STATE OF OHIO
DEPARTMENT OF HIGHWAYS

Subject Signal Up-grading.

TRAFFIC SIGNAL INSPECTION REPORT

SIGNAL NO 727 LOCATION SR124-SR 506
DATE OF INSTALLATION 8-5-60 DATE OF INSPECTION 9-11-69
COUNTY Highland DIVISION 9

PHOTO # 1

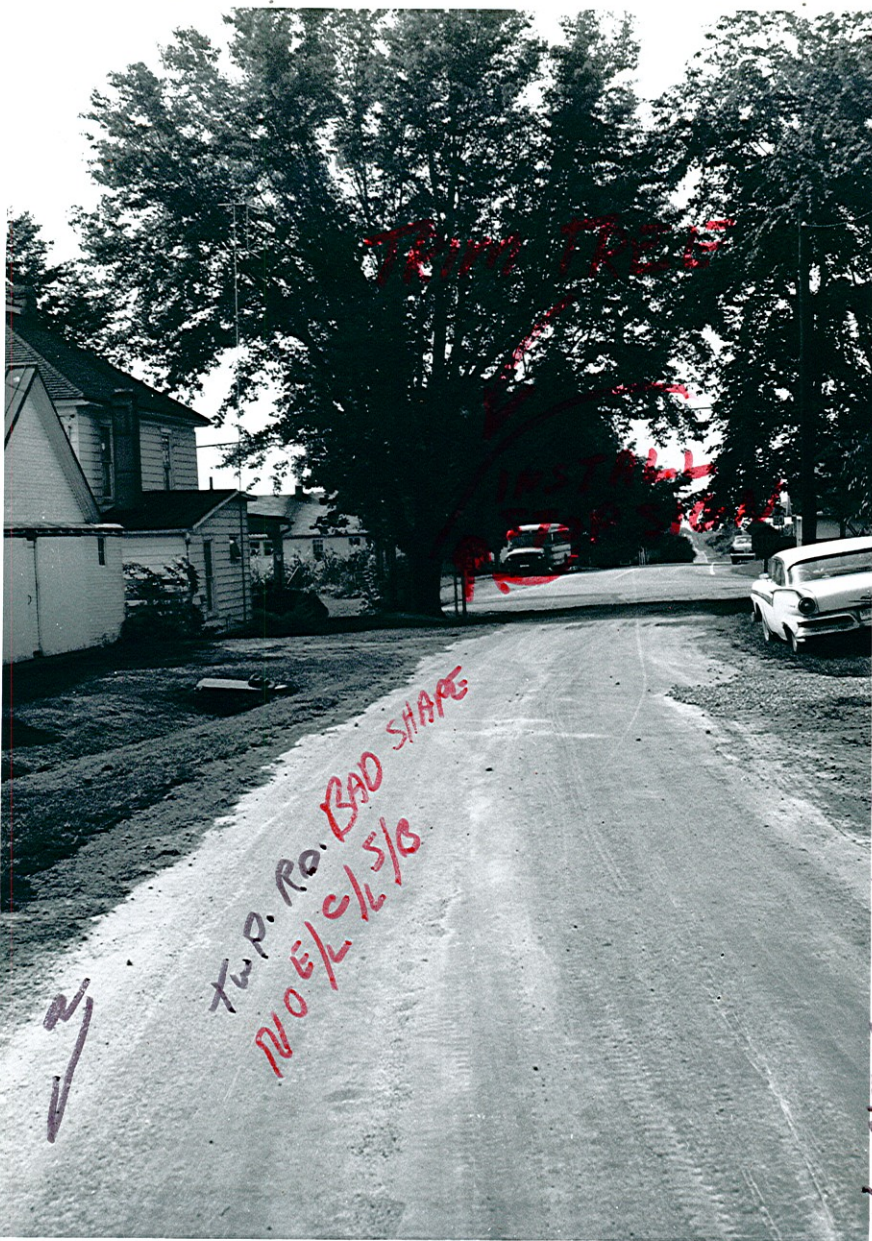
INSTALL STOP SIGN LEFT SIDE
NORTH APPR. TWP. RD. SEE PHOTOS # 1-2
TRIM TREES. See Photos 1-2-4-5
6-7-8.

TRIM TREES

TWP. ROAD
BAD SHAPE
NO. 1000

PHOTO # 4

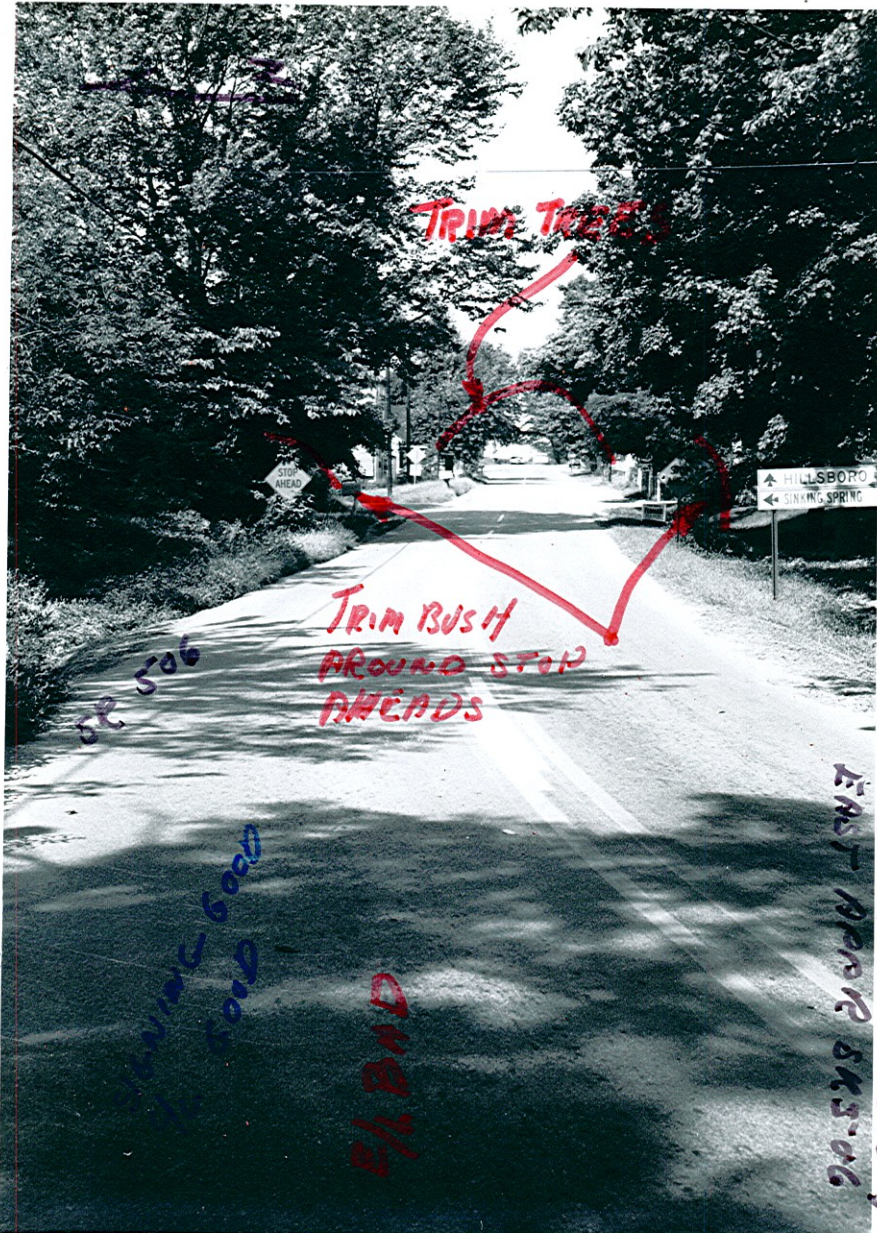
TRIM TREE

TRIM BUSH
AROUND STOP
AHEADS

PHOTO # 6

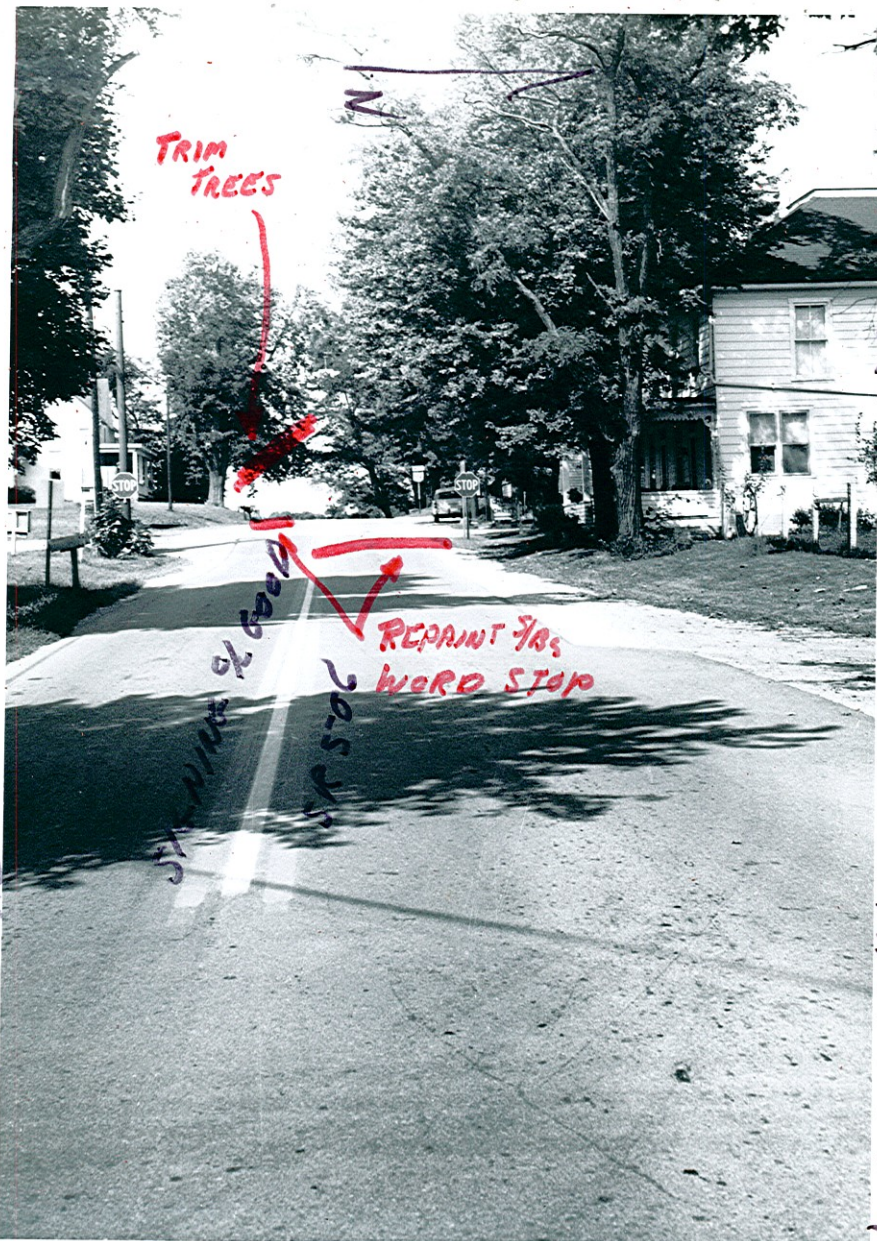
Repaint S/Bs. See Photos 6-8

TRIM TREES

PHOTO 48

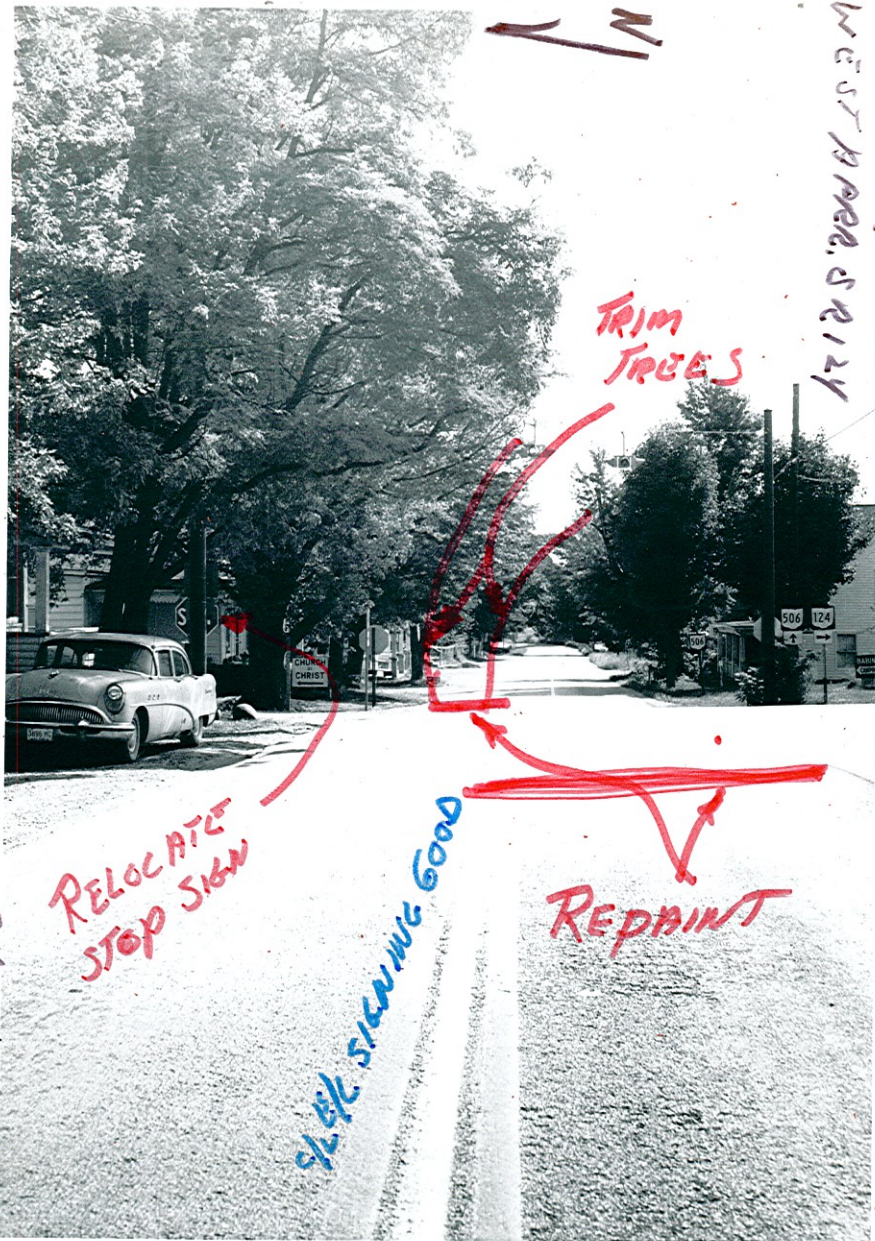
TRIM
TREES

RELOCATE
STOP SIGN

REPAINT

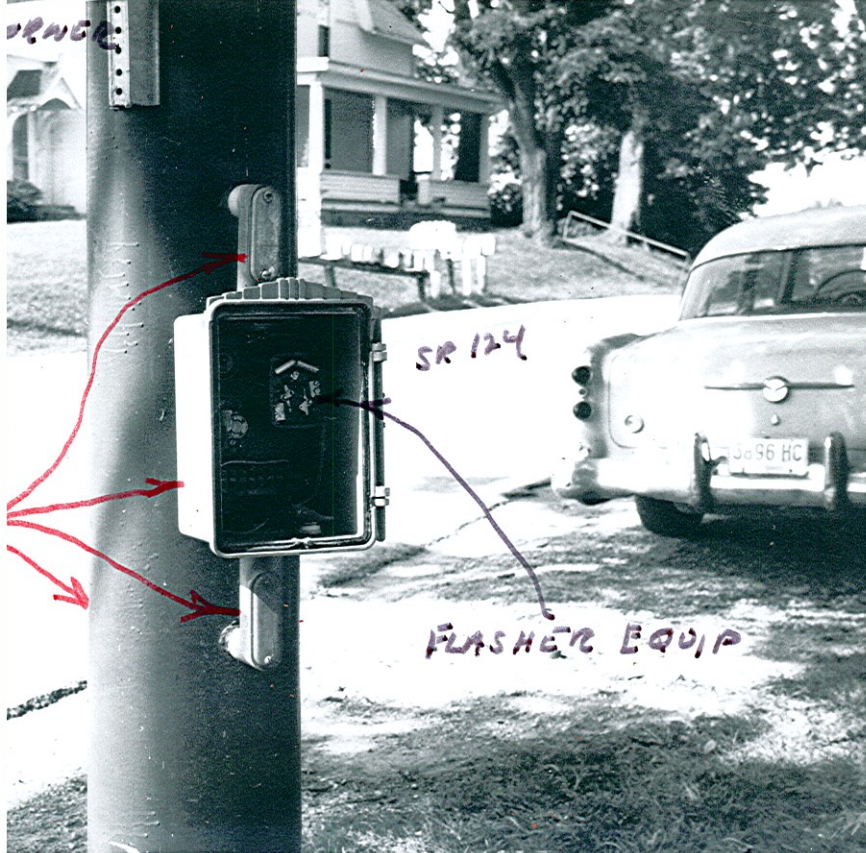
Paint Equipment. See Photo #3

FLASHER EQUIP
